# **SERVICE BULLETIN**

B-008 November 21, 1995

# Safety Recall Code 0805

# 1995 and 1996 S2/S2-T California Models (Qwiksilver Carburetors)

Figure 3. Carburetor Disassembly

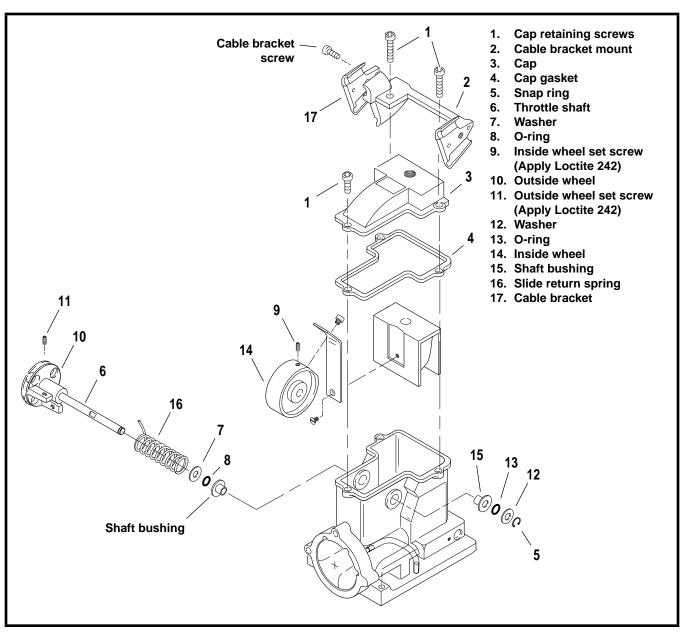
Buell Motorcycle Company has decided that there is a safety related defect with Qwiksilver carburetor used on certain 1995 and 1996 S2 and S2-T California model Buell motorcycles. The throttle cable wheel of the carburetor could move on its shaft and come in contact with the carburetor support bracket. This could prevent the throttle from returning to the at-rest position.

As a precautionary measure, Buell Motorcycle Company elected to initiate a voluntary recall in the interest of motor vehicle safety. The condition will be remedied by replacing the throttle shaft on all potentially affected vehicles.

- See Figure 3. Remove three cap retaining screws (1) and cable bracket mount (2). Remove cap (3) from top of carburetor. Retain gasket (4).
- 2. Remove and discard snap ring (5) from throttle shaft (6). Remove washer (12) and retain O-ring (13).
- Loosen and remove inside wheel set screw (9).
- Remove outside wheel (10) and shaft assembly from carburetor body.
- Retain spring, all washers, o-rings, and shaft bushings. Shaft bushings should remain pressed in carburetor body.
- Loosen set screw (11) on outside wheel and remove shaft.

- 1. Install new snap ring (5) on shaft.
- 2. Install washer (12) and O-ring (13) on shaft.
- Slide shaft assembly through carburetor body and inside wheel (14).

- 4. Remove freeplay so O-ring (13) seats lightly against shaft bushing (15) and center inside wheel (14).
- Apply LOCTITE THREADLOCKER 242 (blue) to inner wheel set screw (9) and tighten in position on flat area of shaft
- 6. Install O-ring (8), washer (7) and slide return spring (16).
- Install outside wheel (10).
- Apply LOCTITE THREADLOCKER 242 (blue) to outside wheel set screw (11) and tighten in position on flat area of shaft.
- 9. Check throttle shaft for free movement.
- 10. Install cap (3), cap gasket (4) and cable bracket mount (2).
